**METROPOLITAN GOVERNMENT OF NASHVILLE AND DAVIDSON COUNTY**

**STAFF RECOMMENDATION**  
**2400 Barton Avenue**  
**May 21, 2014**

**Application:** Demolition—outbuilding; New construction-outbuilding; Setback determination

**Description of Project:** The applicant proposes to demolish an existing outbuilding and to construct a new outbuilding on the site of the existing garage. A setback determination is requested from twenty feet (20') to twelve feet (12') from 24<sup>th</sup> Avenue South

Figure 3. Sanborn map from 1957 shows the existing outbuilding.

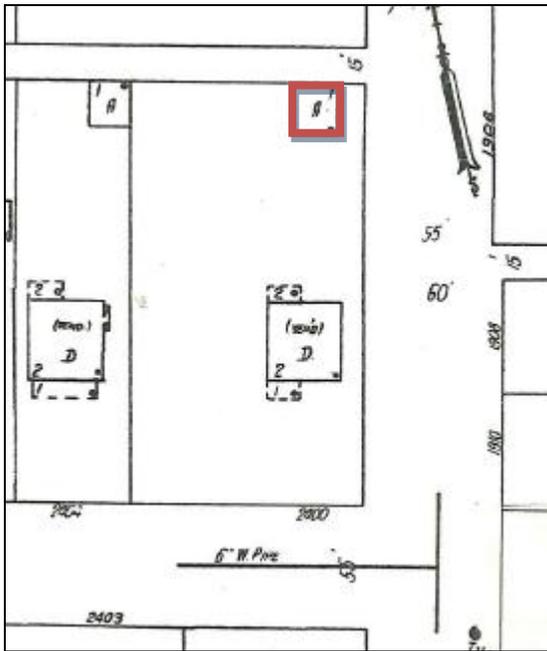
Location & Orientation: The outbuilding will be located on the site of the existing one. The location at the rear of the lot is an appropriate location for an outbuilding. The existing driveway off 24<sup>th</sup> Avenue South will provide vehicular access in accordance with the historic context. As the proposed location is on the existing one, the driveway will not be expanded and there will be no additional curb cut. Two doorways will face the house for pedestrian access. A stoop for these doorways is the extent of the walkways proposed. Staff finds the project meets section II.B.h.2.

Figure 4. Street-facing facade of the proposed outbuilding.

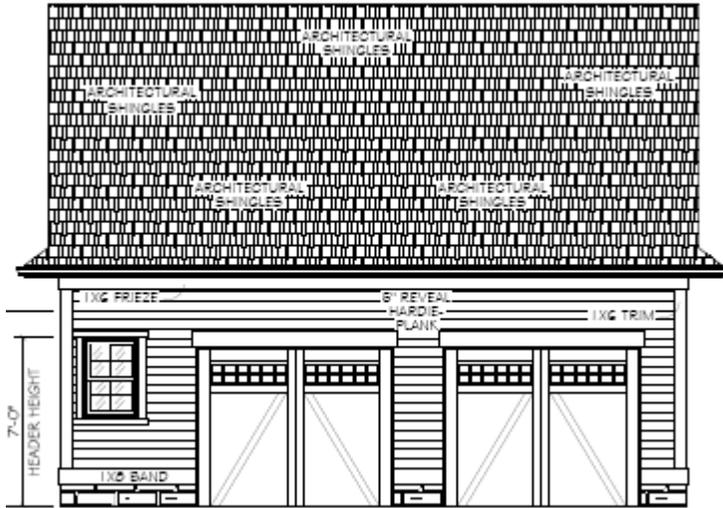
Height, Scale, Design: The outbuilding is proposed to be one-and-a-half stories and twenty feet ten inches (20' 10") in ridge height from grade, and twenty-six feet (26') square for a total footprint of six hundred and seventy-six square feet (676 sq.ft.). Eave height is ten feet (10'). This is appropriately subordinate to the primary building, which

has a height of thirty-six feet (36') from grade. Its height and scale are similar to outbuildings at 2401 and 2403 Fairfax Avenue that the Commission approved in 2013. Staff finds the design of the proposed building is compatible with the context, and the project meets section II.B.h.1 of the design guidelines.

FRONT ELEVATION

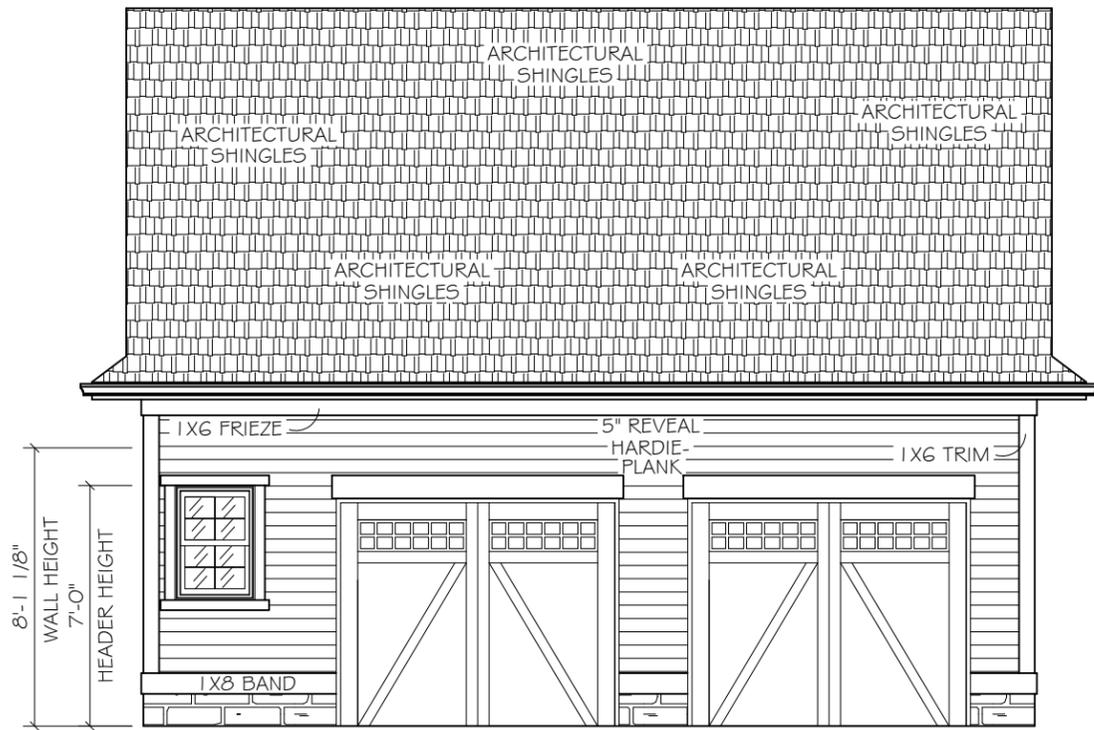
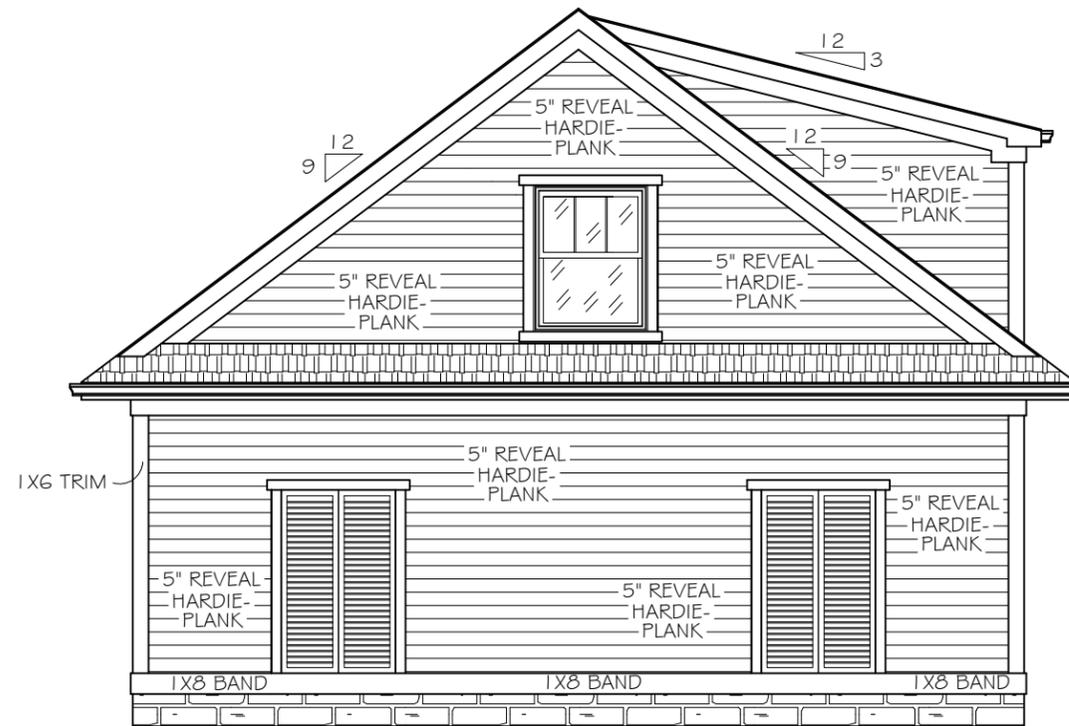
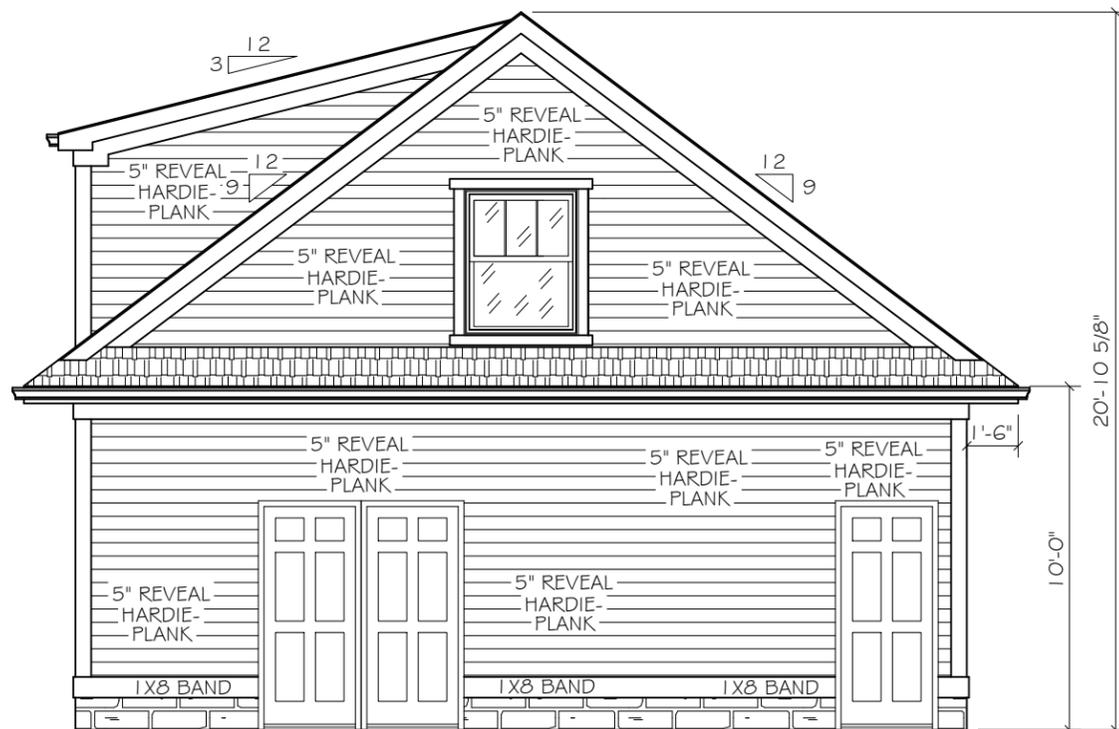
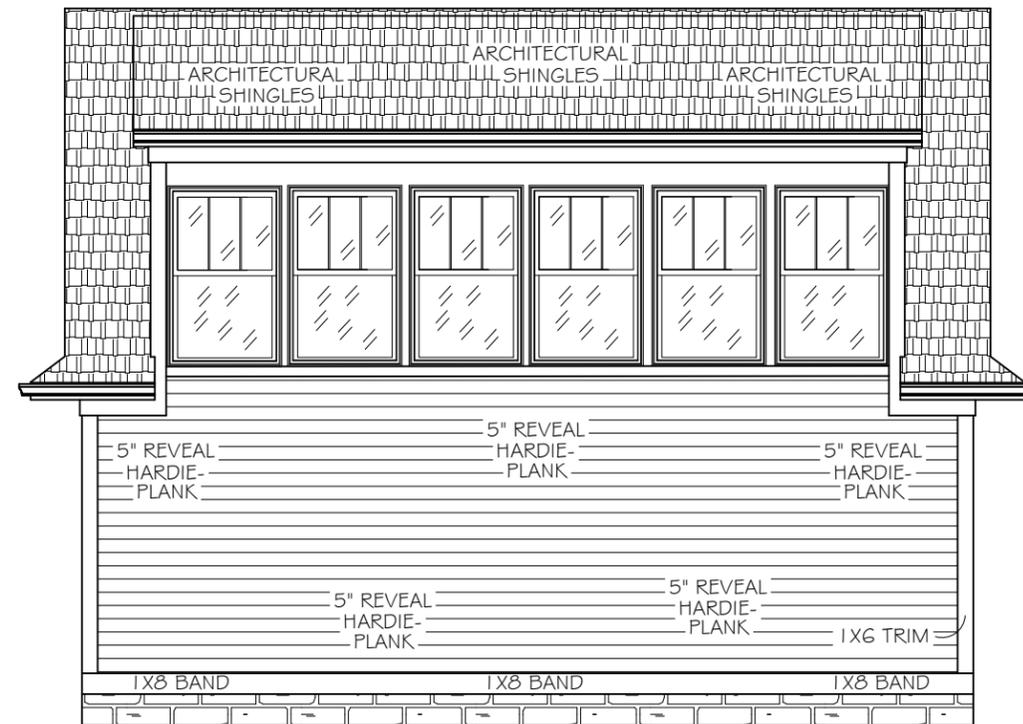
**Materials:** The materials for the proposed outbuilding are cement fiber siding with a five inch (5") reveal, wood trim, concrete block foundation and architectural shingles. The windows and doors were not specified; staff asks to approve the final window, door and garage door selections prior to purchase and installation. With the staff's final approval of the windows, doors and garage doors, staff finds that the materials meet section II.B.h.1.

**Roof form:** The outbuilding's primary roof form is a side gable with a pitch of 9/12. A rear shed dormer has 3/12 pitch. Staff finds the roof form is compatible with other structures in the neighborhood. The project meets section II.B.h.1.

Staff recommends approval of the demolition, new outbuilding, and setback determination with the condition that staff approves windows, doors, garage doors and the color of roofing material. With this condition, staff finds that the project meets II.B.h of the Hillsboro-West End Neighborhood Conservation Zoning Overlay Design Guidelines.
